Subject: [EXTERNAL] RE: PIRATE I/L Additional Questions 5/10 & 5/11

From: Kevin Rice <kprice@up.com>
Sent: Tuesday, May 17, 2022 2:07 PM
To: Buckley, Maggie <Maggie.Buckley@jacobs.com>
Cc: Assenza, Adam <adam.assenza@stb.gov>; Phoebus, Elizabeth (Betsi) <Betsi.Phoebus@jacobs.com>
Subject: [EXTERNAL] PIRATE I/L Additional Questions 5/10 & 5/11

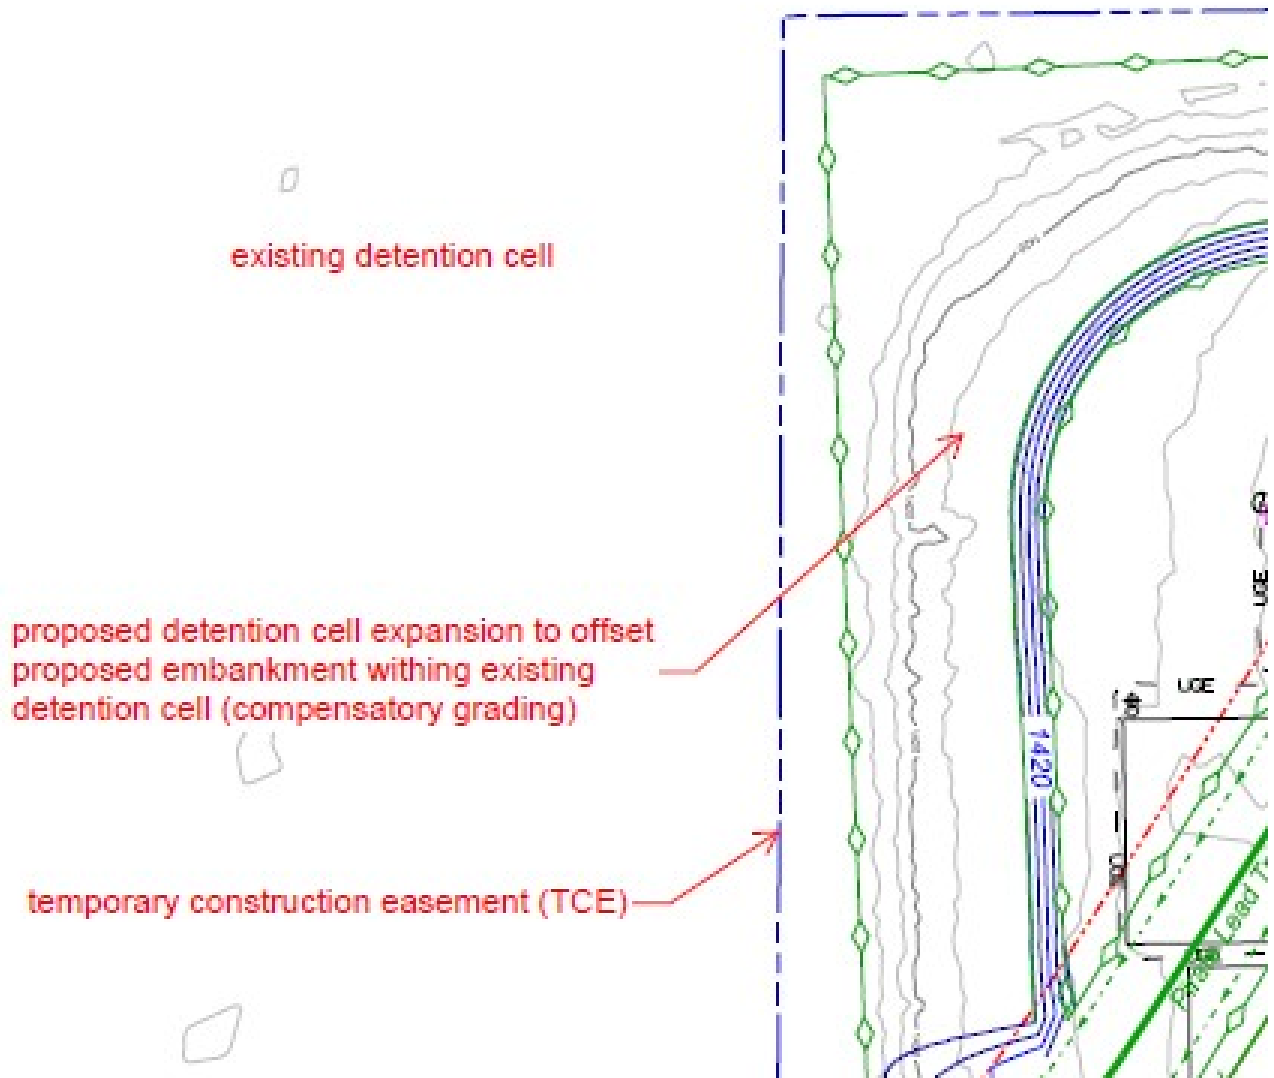
1. We are drafting the project description and looking for clarification on how the detention cell will function near TRW as shown on Sheet P034. Sheet P034 references Sheet R003 for grading details, but R003 is not included in the 30% plan set. We are trying to understand how the basin is going to function or interact with the new drainage ditch in this area. Was a Stormwater Report created for the 30% design that might also include this information?

{from our consultant} Sheet R003 was a work in progress at submittal of 30% Plans. The note on P034 referencing Sheet R003 was a placeholder for the attached draft sheet that includes description/explanation of proposed improvements.

A draft drainage report is near completion, which will then be submitted to UPRR for concurrence of recommendations, then followed by submittal to agencies for review. If requested, we can provide the drainage report upon completion. {when that final drainage plan is available, I will provide it, the working draft is shown below}
